ENCLOSURE 5 TO NL-09-036

Applied Science Associates, Inc. Report dated March 16, 2009,
"Review of Thermal Discharge Issues to the Hudson River in NRC Draft
SEIS for Indian Point 2 and 3"

ENTERGY NUCLEAR OPERATIONS, INC.
INDIAN POINT NUCLEAR GENERATING UNIT NOS. 2 and 3
DOCKETS 50-247 and 50-286

**Review of Thermal Discharge Issues to the Hudson
River in NRC Draft SEIS for Indian Point 2 and 3**

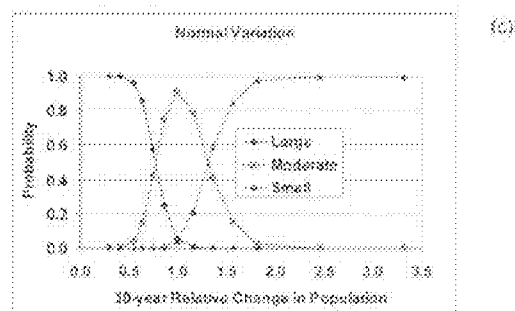
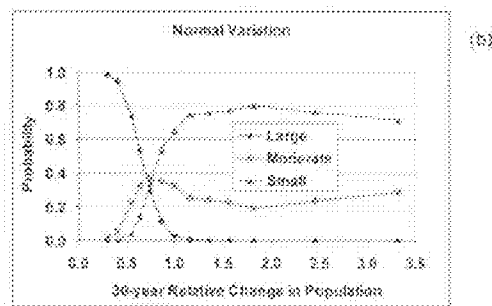
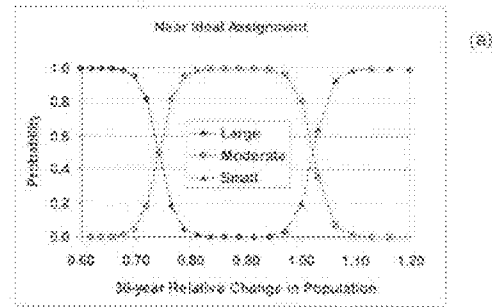
Classification probabilities for an "ideal" procedure are illustrated in figure 1a, and the probabilities calculated for NRC's classification procedure are illustrated in figure 1b. In Figure 1a, the ranges of population change over which more than one classification is possible are small (-0.65 to -0.85 and -0.95 to -1.1), and there are no rates of population change for which more than two classifications are possible. As shown in Figure 1b, probabilities of misclassification are high using NRC's procedure. There is a 20%-40% chance that a trend will be classified as Moderate for population

To illustrate the potential for improvement of the classification process, a simpler set of rules was applied to the simulated data (Appendix A). This scheme produced Large, Moderate, and Small classifications that were much more distinct than those produced by NRC's rules (Figure 1c). Separation of the Large and Small categories was nearly complete, and a Moderate category centered on relative change ≈ 1 , where the probability of Large and Small was very low. The zones of overlap of two categories, either Large with Moderate or Moderate with Small, are much smaller than with the classification rules used by NRC. This alternate classification is still conservative, because population that are growing, but at a relatively low rate (up to about a 120% increase over 30 years) have a higher probability of being incorrectly classified as Moderate than of being correctly classified as Small.

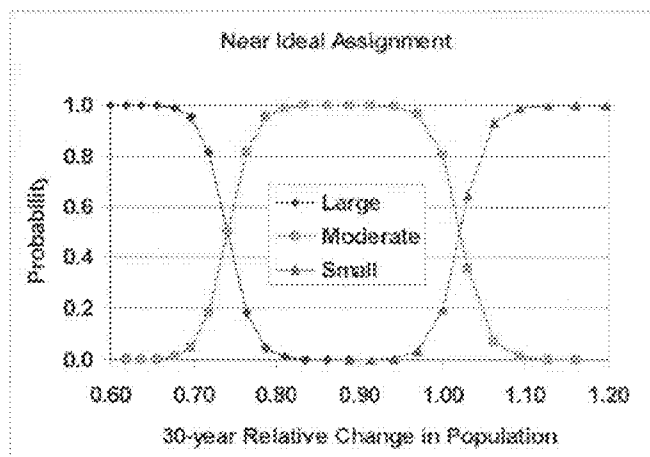
Ideally, a classification process would be able to delineate distinct classes based on true values of population parameters. An ideal classification process would have large ranges of population change where only one of the classes is possible, and small ranges where probabilities for two classes overlap (Figure B-2). The nearly ideal hypothetical classification depicted has uncertainty in classification only when 30-year relative change in the population is near 0.75 or 1.05. In each case the uncertainty is only between two of the three classes.

Figure B-3. Classification under NRC decision rules of simulated population abundance data with normal variation around the expected value, $\delta = 0.25$. Probabilities for the three classifications always sum to unity.

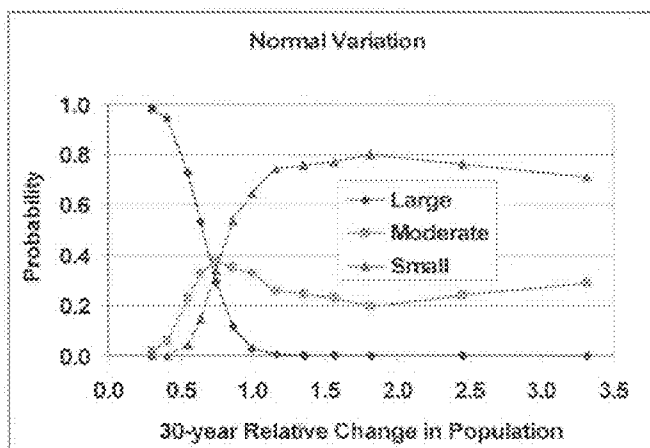
The NRC process, for a population with normal variation in annual abundance and $\delta \approx 0.25$, departs substantially from the ideal (Figure B-3). The delineation between the Large and Small categories of potential impact was relatively distinct, with overlap of the categories occurring only in the range of 0.5 to 1.0 relative change in population size. However, the probability that a population could be classified as Moderate potential impact was between 0.2 and 0.4 for population change ranging from 0.5 to 3.3, i.e. a population that had declined to 50% of its original abundance and a population that had grown to more than 3 times its original abundance have essentially the same probability of being classified as Moderate potential impact. The probability that a population would be classified as having a Large potential impact was also non-trivial for populations that had declined relatively little: 0.32 for a trend resulting in 0.7 of initial abundance, 0.12 for a trend resulting in 0.9 of initial abundance, and 0.03 for a population with unchanged abundance. The 0.6 to 0.9 range in population change is a zone in which discrimination is highly uncertain as the probabilities of the Large potential impact category range from 0.53 to 0.11; probabilities of the Moderate category range from 0.33 to 0.37; and probabilities of the Small category range from 0.14 to 0.65.

Figure B-4 Classification under NRC decision rules of simulated population abundance data with log-normal variation around the expected value, $\delta = 0.25$. Probabilities for the three classifications always sum to unity.

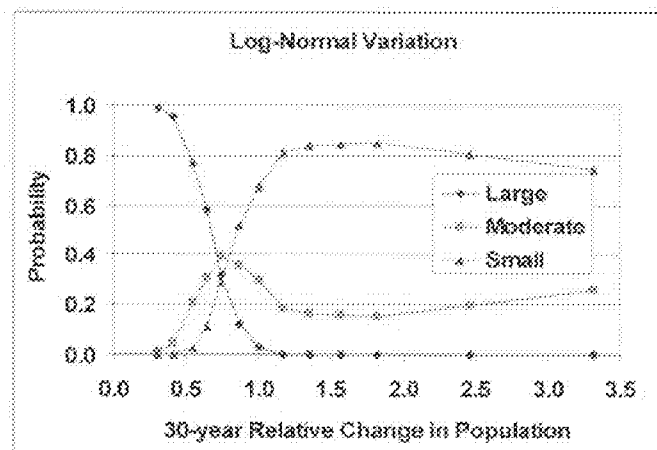
If population variation is lognormal rather than normal, the operating characteristics of the NRC classification are essentially the same (Figure B-4), although

between relative population change from about 1.2 to 2.5 the probability of a population being classified as Moderate impact declines slightly below 0.2.

Figure B-5 Classification under NRC decision rules of simulated population abundance data with normal variation around the expected value, $\delta = 0.25$, after applying a 3-year moving average. Probabilities for the three classifications always sum to unity.

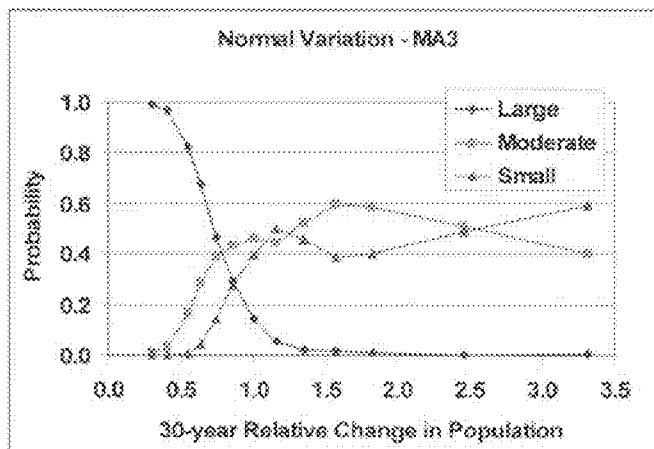
Smoothing the data series with a 3-year moving average prior to analysis resulted in the classification process being even less able to distinguish Moderate from Small impact. Populations that increased in abundance (population change greater than 1.0) had nearly equal likelihood of being classified Small or Moderate (Figure B-5).

Figure B-6 Classification under NRC decision rules of simulated population abundance data with normal variation around the expected value, $\delta = 0.10$. Probabilities for the three classifications always sum to unity.

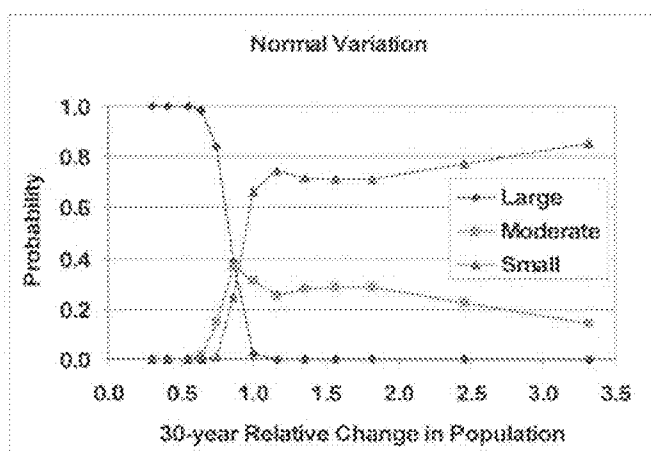
Simulation results for less variable population abundances, $\delta = 0.10$, were also qualitatively similar although the probability of a Moderate classification began to drop below 0.2 at population changes above 2.5 (Figure B-6).

Figure B-7 Classification of simulated population abundance data with normal variation around the expected value, $\delta = 0.25$, under rules based on significant positive or negative slopes, each considered significant if $p < 0.10$. Probabilities for the three classifications always sum to unity.

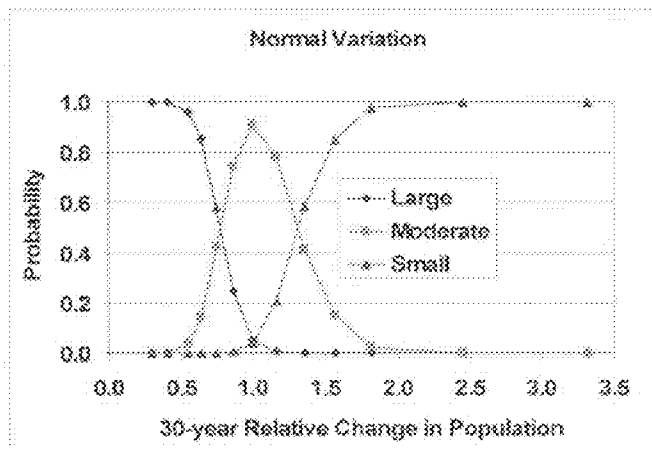
This rule resulted in nearly complete separation of the Large and Small categories, and a Moderate category centered on relative change $= 1$, where the probability of Large and Small was very low (Figure B-7). The zones of overlap of two categories, either Large with Moderate or Moderate with Small, are much smaller than with the classification rules used by NRC. This classification scheme may or may not be preferable for NRC's purpose, but it illustrates that different sets of rules can produce very different classifications for the same data, and that no classification scheme should be used without first testing its performance on data with known characteristics.
